RE: Progress Report
Abo 1G Pipeline Release NMOCD Case #1R0415
Section 1, 17S, 36E, Unit G

RE: Amended Corrective Action Plan
Abo 1G Pipeline Release NMOCD Case #1R0415
Section 1, 17S, 36E, Unit G

This letter responds to the technical issues brought forth in the NMOCD letter to Rice Operating Company (ROC) dated July 8, 2005. Hicks Consultants collaborated with ROC staff to develop this response. The NMOCD technical comments or requirements are shown in italics and our response is presented below each comment or requirement.

The New Mexico Oil Conservation Division (NMOCD) is in receipt of Rice Operating Company's (ROC) Amended Corrective Action Plan dated March 2005 submitted by R.T. Hicks Consultants, Ltd. The plan concluded that the produced water released represented no threat to ground water quality. These assumptions were predicted by the utilization of the HYDRUS-1D model. The following three recommendations were presented.

Figure1 : Chloride Concentration Observed in the Aquifer at the Down Gradient Edge of a North-South Road with a 6 inch thick Layer of 1200 ppm Caliche

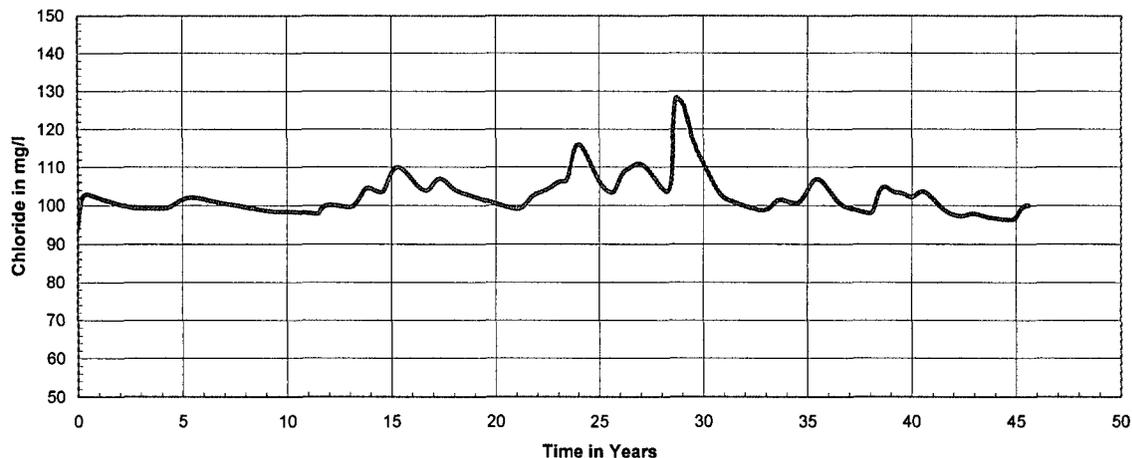
We offer the following idea for NMOCD consideration. Underlying the surface soil at the site is about 1-3 feet of hard caliche with an average chloride concentration of 1,200 mg/kg (see Table 1). As part of the conditional approval of the remedy proposed in the August 2005 Amended Corrective Action Plan, NMOCD requires disposal of this material to reduce the chloride mass that exists at this spill site. Rather than dispose of this material at a landfill, we propose to excavate and remove this caliche material in the area of the excavation and cap and use the caliche for the repair of nearby roads or minor repairs to well pads. Rather than create a waste for disposal at a landfill, we propose to create a product: road gravel. ROC will work with the City of Lovington to identify nearby roads in need of repair. ROC will spread this caliche gravel on 15-foot wide roads that run perpendicular to ground water flow (essentially north-south roads) to a thickness that will not exceed an average of 6-inches.

We employed the data and assumptions discussed below and the modeling protocol outlined in the Amended Corrective Action Plan to predict the potential impact of this reduce-reuse-recycle program. Using this caliche as road gravel at nearby locations is consistent with NMOCD's stated goal of reducing the mass of chloride present at this site.

Figure 1 presents the model's prediction of chloride concentration in a monitoring well immediately down gradient of a road that is repaired by the application of 6 inches of caliche from the site. Within the mixing model at time = 0, ground water that enters the mixing zone has a chloride concentration of 93 mg/L, the value of the input discussed above. Soon after time=0, the additional natural chloride flux from the vadose zone to the aquifer causes the predicted chloride concentration in ground water to vary between 102 and 99 ppm until about year 12. Between year 12 and year 22, the natural flux of chloride into the aquifer increases as a result of "wet" years within the atmospheric data, causing an additional predicted increase of chloride to about 110 ppm. To reiterate, these variations in chloride concentrations predicted in the model for years 0-22 result from natural conditions and are not due to the installation of caliche road repairs.

Our analysis of the model output shows that chloride molecules from the caliche pad begin to enter ground water about year 24. The center of mass of chloride leached from the caliche road repair intercepts ground water about year 29 and creates a maximum chloride concentration of 128 mg/l or about 19 mg/L greater than the maximum concentration due to natural causes. Although the highly-conservative model predicts a natural chloride variation from 93 to 110 mg/L, the natural variation of chloride concentration is documented at MW-1 as a variation between 72 mg/L and 120 mg/L. Because the natural variation is 48 ppm, the theoretical contribution of chloride to the aquifer (19 mg/L) from the caliche road repair is too small to be detected.

Figure 1. Chloride concentrations v. depth.

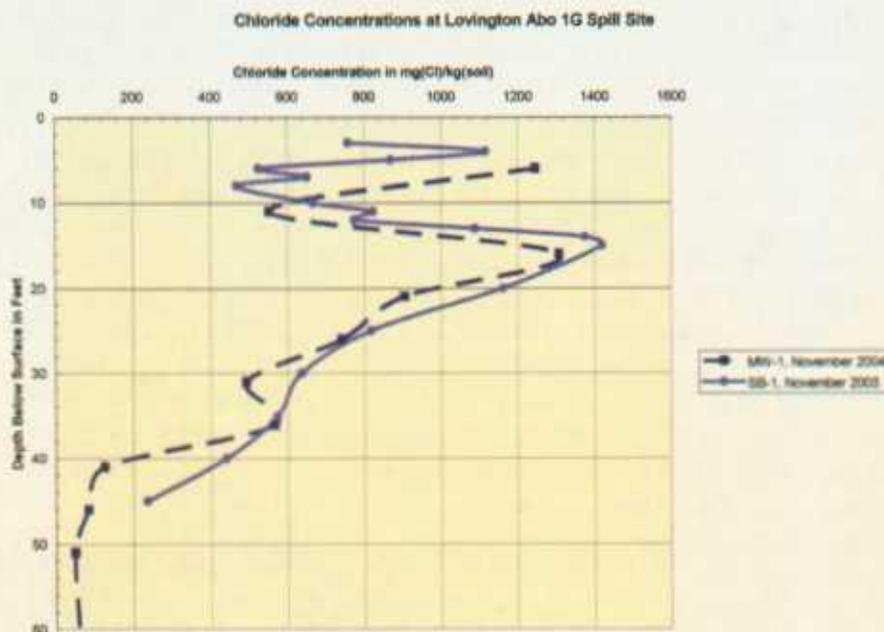
Figure 1 shows that peak measured chloride concentration of the upper chloride center of mass has migrated approximately two feet downward in the 12-month period (November 2003 to November 2004). We believe that the recent rain events may have temporarily created saturated flow in the upper soil profile moving the chloride into the sand and caliche layer below the upper fractured caliche.

The recent precipitation did not affect the downward migration of the 2003 peak chloride concentration (at 15 feet) in the same manner. As Figure 1 implies, the 2004 peak chloride concentration is at a depth of 16 feet, suggesting a migration rate of approximately one foot per year.

Figure 5. Predicted chloride concentrations of January 2005 simulations

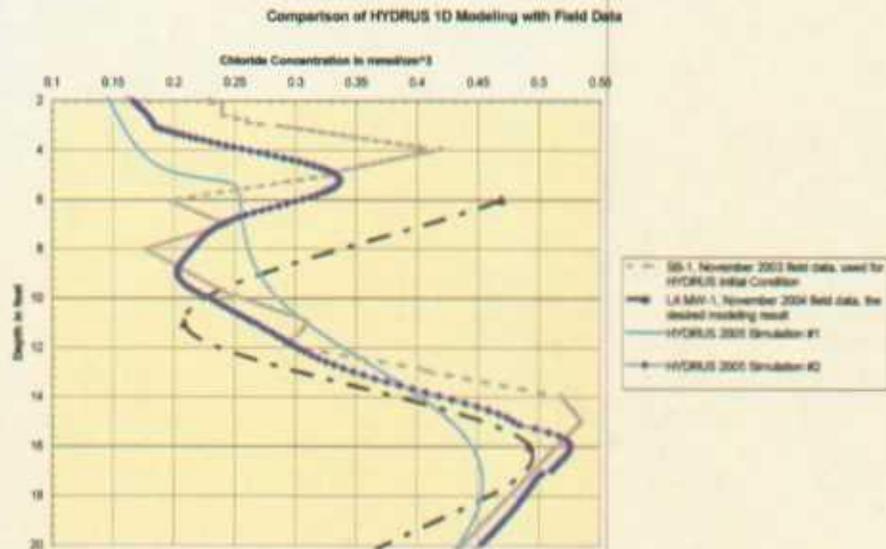
Figure 5 plots the predicted chloride concentrations of Simulations 1 (data shown in a solid line) and Simulation 2 (calibrated simulation, line marked with diamonds) versus the observed field data obtained in November 2003 (SB-1, dashed line) and November 2004 (MW-1, dashed line with triangles). See Plate 4 for the full profiles. According to Figure 1 of this submission, the upper center of chloride mass moved downwards about two feet

during the period between the sampling of SB-1 and the sampling of LA MW-1. The lower chloride mass moved slightly over one foot within the caliche layer at 15 to 17 feet bgs during this time interval. Clearly the density of data represented in Figure 1 introduces some error to these estimates. For the purposes of this report we accept these estimates and assume that Figure 1 shows the actual migration rate of the chloride.

The HYDRUS-1D 2005 Simulation #1, run with the recent Hobbs weather data shows a dispersion of the upper chloride mass (See Figure 5) for November 2004. The lower chloride mass also shows dispersion along with a downwards migration of the peak chloride concentration to a depth of 17 feet.
